SUBDIVISION REVIEW SHEET

CASE NO.: C8J-2019-0141.2A

SUBDIVISION NAME: Skyline 2-D Phase 2 Final Plat

CITY OF AUSTIN –DEVELOPMENT SERVICES DEPARTMENT
SUBDIVISION APPLICATION – MASTER COMMENT REPORT

SHEET NO. 2 OF 4

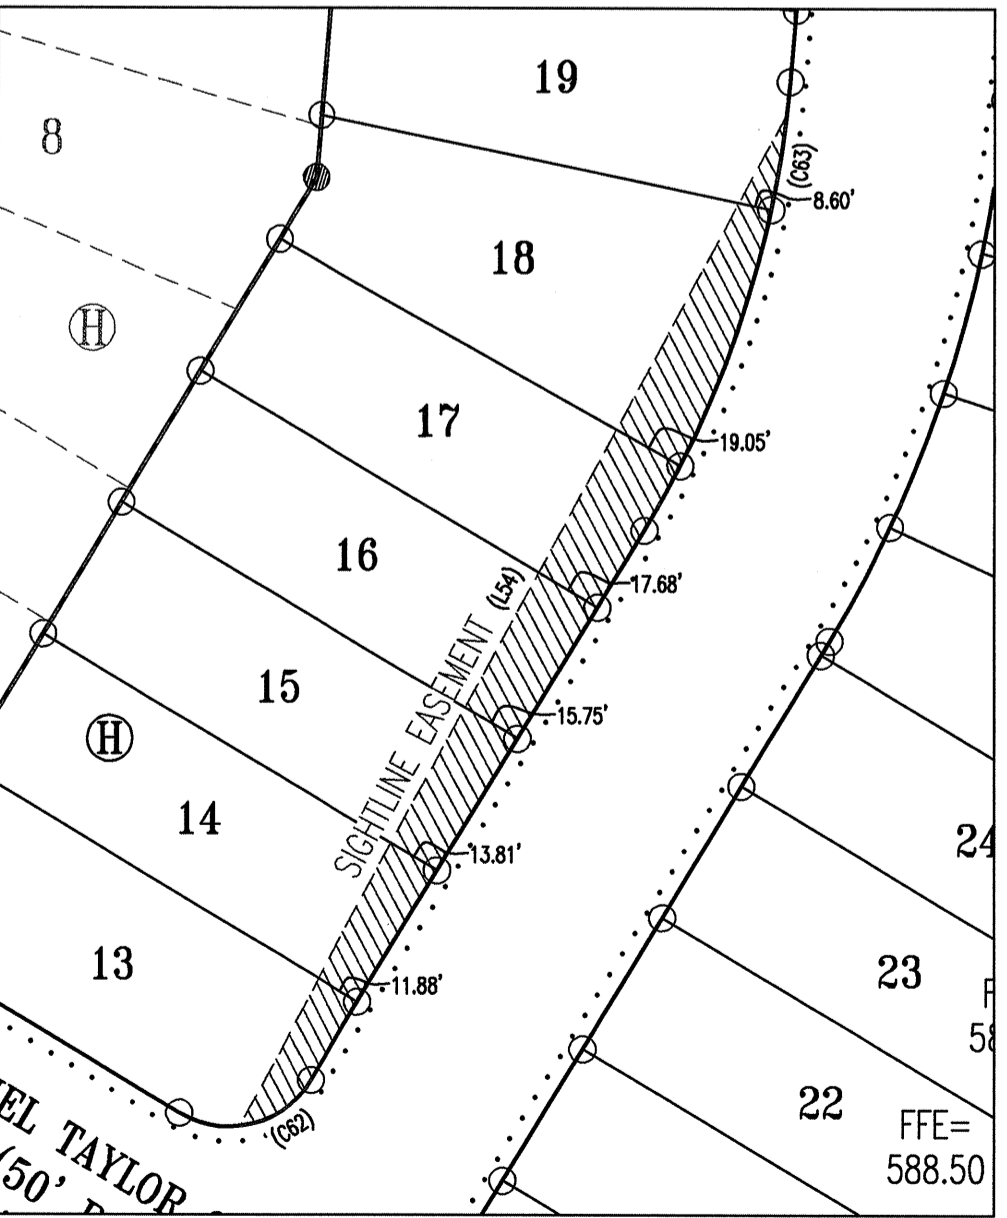
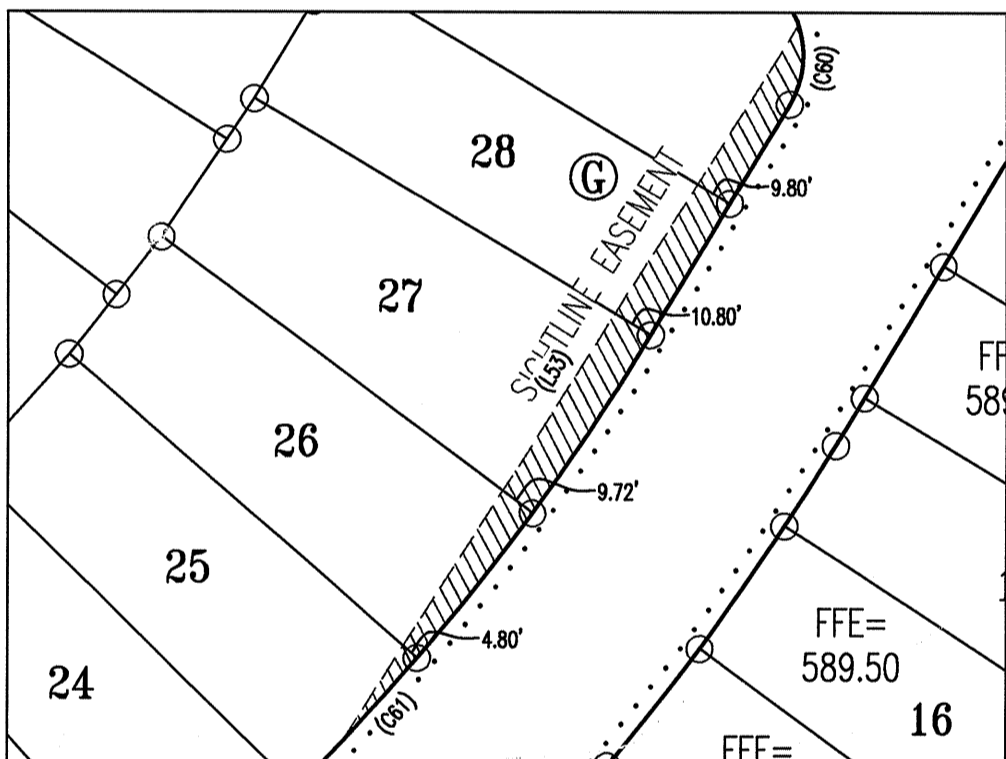
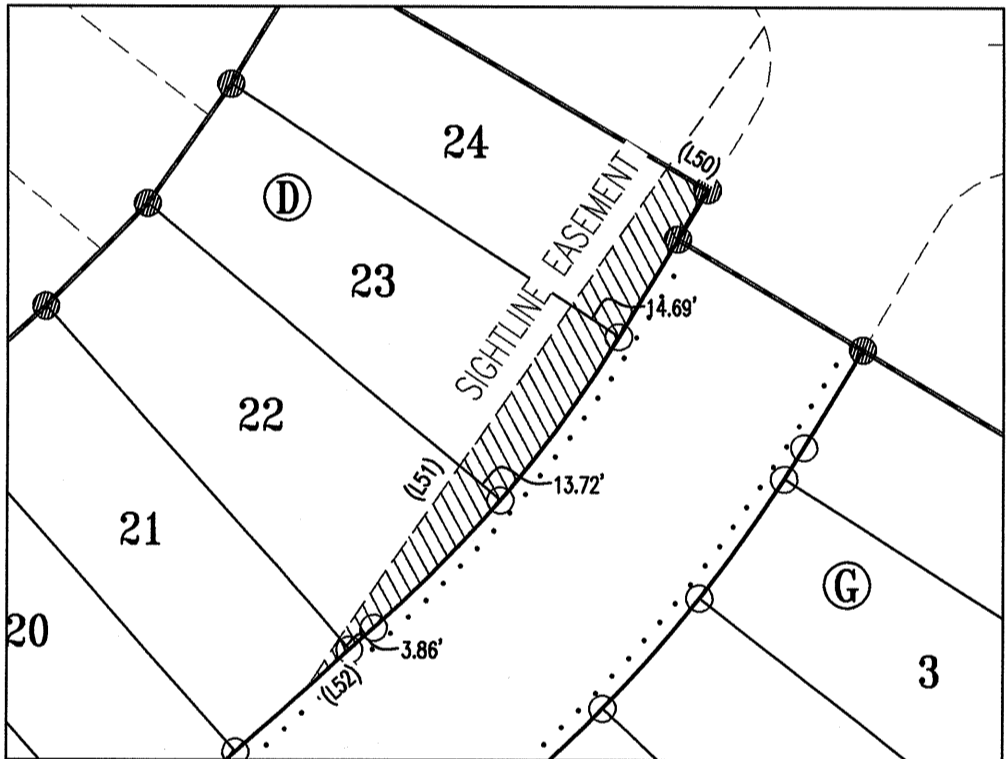
ZR2. Please confirm with the Case Manager/ and or the City Arborist to ensure that the note on sheet 2 that is referencing SF4A Zoning and SF Zoning is needed/ correct (25-1-83)

WB3. Update0. Please add Note #38 (Riparian restoration is required in the CWQZ. A riparian restoration plan...) on Sheet 2 of the Approved Preliminary Plan Skyline 2D 11-11-2020 to the final plat notes.

EV 1 Remove the critical water quality zone from the plat. Add the following note: *“Waterway setbacks as defined by the Land Development Code may be located on this property. Development is limited within waterway setbacks.”* [LDC 25-8, Article 7]

ZR1. Lot 23 and Lot 14 in Block H, Lot 16 in Block D, and Lot 9 and Lot 38 in Block K- it looks like text/ numbers are overlapping and it is difficult to read the information in the lot, please correct in order to see all of the information in all lots (25-1-83).

WB2. Update0. Please clearly show the boundaries of the one wetland CEF within 150 feet of the plat to be preserved and clearly label the feature “Wetland CEF” on the plat.
